Dubbo Base Hospital – EPA Additional Information. Acoustics

I represent the sound and vibration business section for Norman Disney and Young. Recently we prepared an REF and SSD DA acoustic assessment report for the Dubbo Base Hospital Redevelopment. The REF has since been reviewed by the EPA. The EPA has issued an assessment of our REF report and has requested additional information as per document DOC12/47285.

Figure 1. Noise Logging – Environmental Conditions and Considerations.

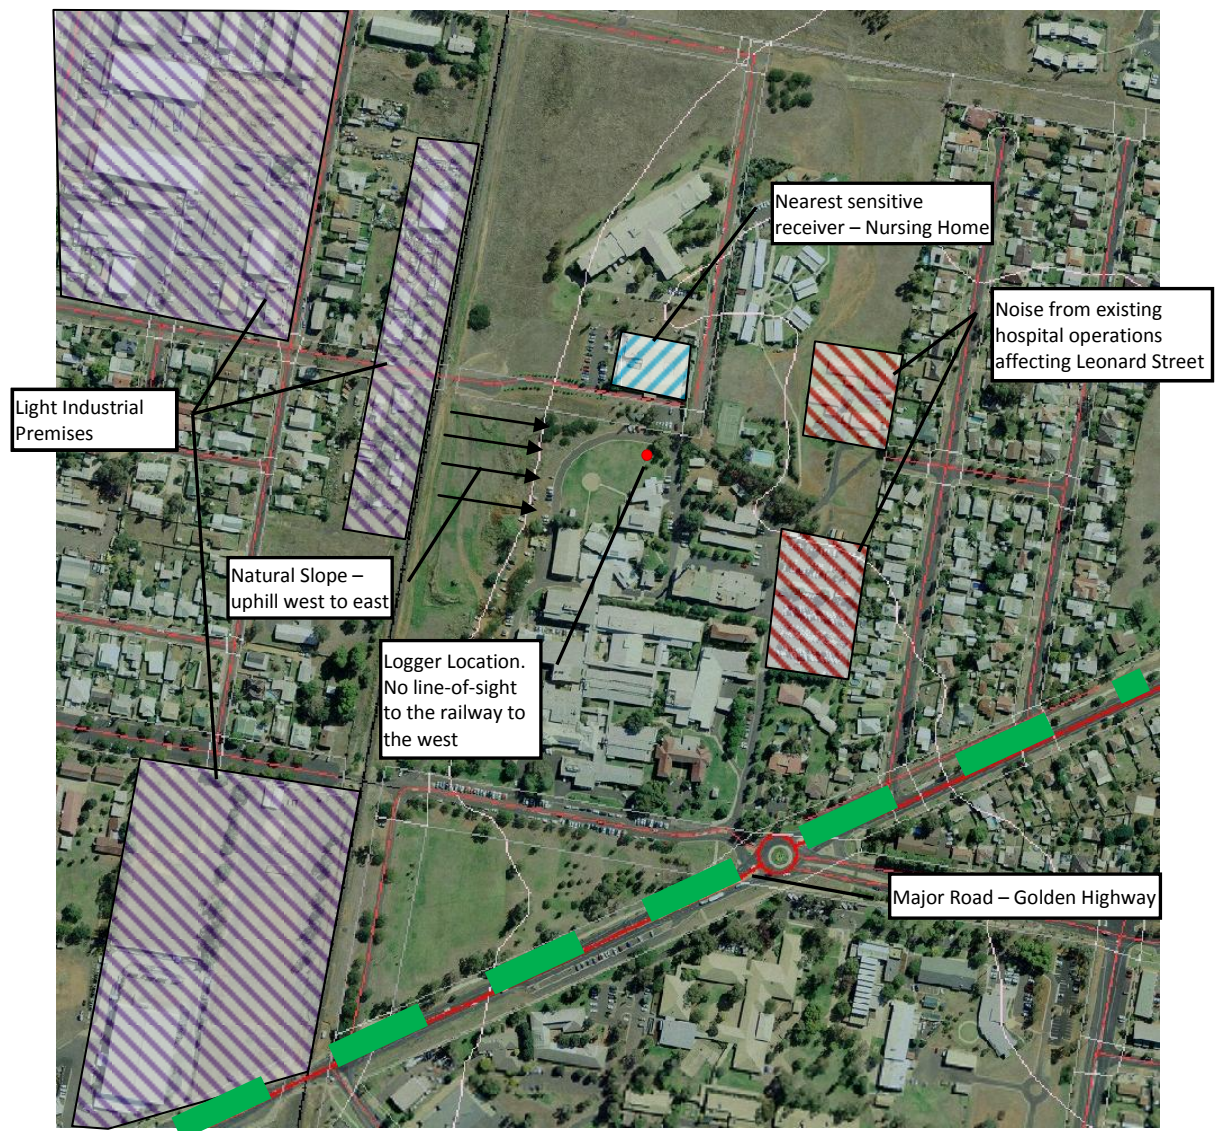
-
- Ordinarily, background noise levels would be measured in the vicinity of the surrounding sensitive receivers (eg. residences along Leonard Street and Morgan Street, etc.) rather than within the subject site. The EPA considers that the results from the noise logger location may not be adequately representative of these two (possibly different) noise environments.
 - The EPA considers that additional monitoring should be carried out and presented to accurately quantify the existing noise environment at the sensitive receivers, excluding existing noise from the subject development, to determine appropriate project specific noise levels for the assessment.

The nursing home to the north of the logging location is the nearest noise sensitive receiver, so in this non-typical development it is practical to place the noise logging equipment on the subject site. In addition the NSW INP requires that a 'representative' background noise level for the day evening and night is obtained from the long-term noise logging. For this particular site we are of the opinion that the selected logging location is 'representative' of the background noise level of the residences adjacent to the site along Leonard and Morgan Street. The following conditions onsite were noted which precluded noise logging at the residences along Leonard and Morgan Street. Figure 1 below also illustrates these points graphically for ease of reference.

- The Golden Highway to the south of the site is a major road that will influence the background noise levels along Leonard Street with those at the southern end of the street having a higher background noise level than those at the north. Therefore, noise logging to the south of Leonard Street would record high background noise levels and subsequently provide higher environmental criteria.

- Towards the northern end of Leonard Street the background noise levels are influenced by the operation of the existing car park and mechanical plant from the hospital buildings. Therefore, noise logging in this area would be unduly influenced by existing industrial noise.

- Light industrial premises are situated just west of the railway track that runs down the western boundary of the hospital site. Further light industrial premises were also noted to the north and south of Morgan Street. Therefore, the noise logging at residences along Morgan Street would be unduly influenced by existing industrial noise.

- The selected location for noise logging is situated at the top of a natural slope. Therefore, the noise logger does not have line-of-sight to the railway tracks and light industrial premises to the west of the site. Therefore, this location was not unduly influenced by existing industrial or extraneous noise (railway noise).

- The selected noise logger location is well shielded from the extraneous noise (road noise) from the Golden Highway due to the hospital buildings to the south.

For these reasons we are of the opinion that the selected noise logging location was appropriate for this site. Given the variability of the extraneous noise sources (railway and road) affecting the residential receivers we consider the selected logger location conservative, and as a result the environmental noise criteria derived for the site are also conservative. We believe given the considerations of the existing noise environment at the Dubbo Hospital site that no further noise logging is necessary.
